Intersection ID: N/A	Main Street: BALLANTYNE_COMMONS_PY	Cross Street: N/A	Location:	NE
ADA ID: 4E6BDA311337	Ramp Type: Perp	Initial Pass/Fail: Fail	Overall Compliance: No	Severity Score: 12.5

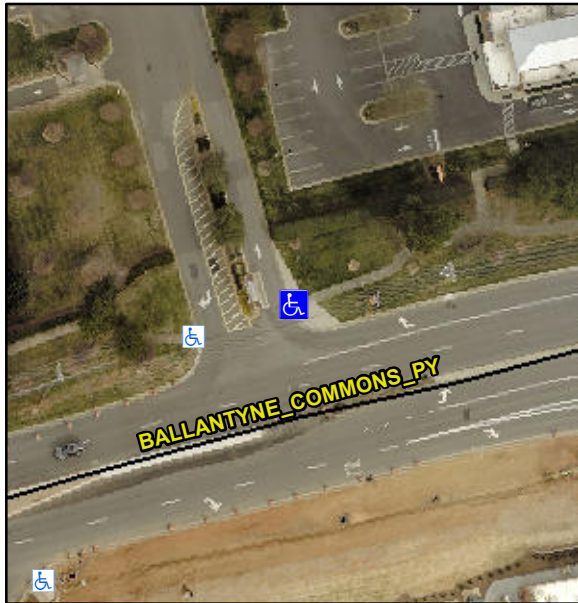
**Not Found, R304.2.2**

Compliance	Description	Data	Compliance	Description	Data
N/A	Ramp Length (in)	48.0	No	Ramp Slope (%)	9.2
Yes	Ramp Width (in)	60.0	Yes	Ramp XSlope (%)	0.4
N/A	Flare Type LT	N/A	N/A	Flare Type RT	N/A
N/A	Flare Slope LT (%)	N/A	N/A	Flare Slope RT (%)	N/A
N/A	Flare Traversable LT?	N/A	N/A	Flare Traversable RT?	N/A
N/A	Landing Length (in)	N/A	N/A	DWS Provided?	N/A
N/A	Landing Width (in)	N/A	N/A	DWS Contrast?	N/A
N/A	Landing Slope (%)	N/A	N/A	DWS Length (in)	N/A
N/A	Landing X Slope (%)	N/A	N/A	DWS Full Width?	N/A
N/A	Landing Curb? (Y/N)	N/A	N/A	DWS Offset (in)	N/A
N/A	Shared Landing?	N/A			
N/A	Gutter Ponding?	N/A	N/A	Gutter Slope (%)	N/A
N/A	Gutter Lip Ht (in)	N/A	N/A	Gutter X Slope (%)	N/A
N/A	Painted X Walk1?	No	N/A	Painted X Walk2?	N/A
	X Walk 1 Direction	To W		X Walk 2 Direction	N/A
N/A	X Walk 1 Width (in)	N/A	N/A	X Walk 2 Width (in)	N/A
	X Walk 1 Slope (%)	0.2		X Walk 2 Slope (%)	N/A
	X Walk 1 X Slope (%)	0.3		X Walk 2 X Slope (%)	N/A

### Remove & Replace Entire Ramp.
